Access Compliance Report

Public Rights-of-Way

Intersection ID: 21994	Main Street: CREEKBED_LN	Cross Street: PARK_RD	Location: SW
ADA ID: 2C3227D8495F	Ramp Type: PerpDiag	Initial Pass/Fail: Fail	Overall Compliance: No
		Severity Score: 37.5

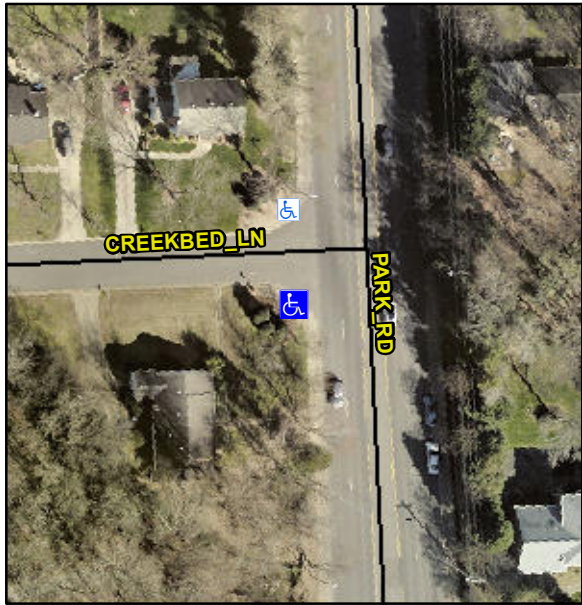
Codes/Mitigation Info/Possible Solution			Field Measurements/Component Compliance					
	Possible Solutions:		Compliance	Description	Data	Compliance	Description	Data
	Remove & Replace Curb Ramp With Two New Directional Ramps or Equivalent.		N/A	Ramp Length (in)	60.0	No	Ramp Slope (%)	9.6
			Yes	Ramp Width (in)	48.0	No	Ramp XSlope (%)	9.3
			N/A	Flare Type LT	N/A	N/A	Flare Type RT	N/A
			N/A	Flare Slope LT (%)	N/A	N/A	Flare Slope RT (%)	N/A
			N/A	Flare Traversable LT?	N/A	N/A	Flare Traversable RT?	N/A
			N/A	Landing Length (in)	N/A	N/A	DWS Provided?	N/A
			N/A	Landing Width (in)	N/A	N/A	DWS Contrast?	N/A
			N/A	Landing Slope (%)	N/A	N/A	DWS Length (in)	N/A
			N/A	Landing X Slope (%)	N/A	N/A	DWS Full Width?	N/A
			N/A	Landing Curb? (Y/N)	N/A	N/A	DWS Offset (in)	N/A
			N/A	Shared Landing?	N/A			
			N/A	Gutter Ponding?	N/A	N/A	Gutter Slope (%)	N/A
			N/A	Gutter Lip Ht (in)	N/A	N/A	Gutter X Slope (%)	N/A
			N/A	Painted X Walk1?	No	N/A	Painted X Walk2?	No

X Walk 1 Direction	To E		X Walk 2 Direction	To N
			N/A	X Walk 1 Width (in)	N/A	N/A	X Walk 2 Width (in)	N/A
				X Walk 1 Slope (%)	6.0		X Walk 2 Slope (%)	1.0
				X Walk 1 X Slope (%)	0.5		X Walk 2 X Slope (%)	6.5
			N/A	Ramp inside XWalk1?	N/A	N/A	Ramp inside XWalk2?	N/A
			Road Slope (%)	6.9	N/A	Clear Space?	N/A	
			Road X Slope (%)	4.1	N/A	Clear Space to XWalk (in)	N/A	
		N/A	Any Obstructions?	N/A	N/A	Storm Grate/Utility Hazard?	N/A	
			Obstruction Type			Storm Grate/Utility Type		
					N/A		N/A	
					Yes	Surface Condition? (G/P)	Good
